# SCHWEIZER SERVICE BULLETIN

DB-026  
24 Oct 2008

**SUBJECT:** MODIFICATION OF CABIN DOOR HINGES

**MODELS AFFECTED:** • 269D Model Helicopters Serial No. 0001 through 0073

Figure DB-026-1. Door Hinge Plate

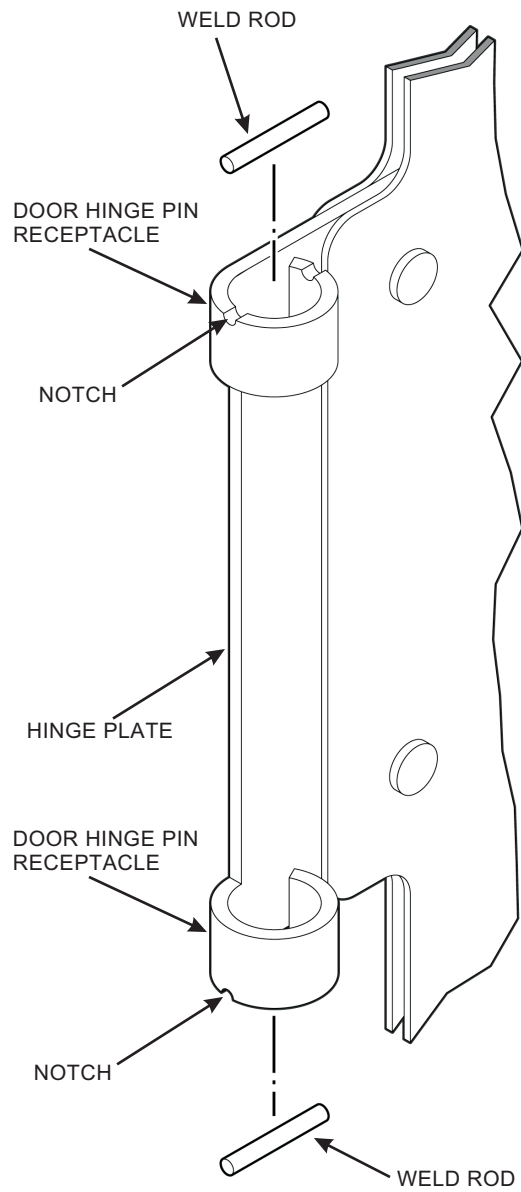
**PREFACE:** • A report has been received that a cabin door separated from a helicopter in flight as a result of the door hinge pins disengaging from the hinge assembly. The hinge pins became free when a serrated release pin came out of the hinge pin. A modification of the door hinge plate has been developed that will prevent the hinge pins from disengaging if the release pins are lost.

- c. Remove paint from two pin receptacles of both door hinges. File small notches in outside edges of pin receptacle 180° apart and centered on holes as shown in Figure DB-026-1. Do not exceed one half diameter of weld rod.
- d. Place weld rod in notches with 0.0625 inch overhang on each side. Using overhang as filter, TIG weld rod to edge of hinge receptacle in accordance with Advisory Circular AC 43.13-1B, Chapter 4, Section 5. File excess material flush with outside diameter of receptacle.
- e. Restore paint finish in accordance with HMI Appendix D.
- f. As required, install doors on helicopter.

Instead of modifying the door hinge plates as directed below, the hinge plates may be replaced with a 269A4755-13 hinge half that has been reconfigured with a cap welded to the outside end of the door hinge pin receptacle.
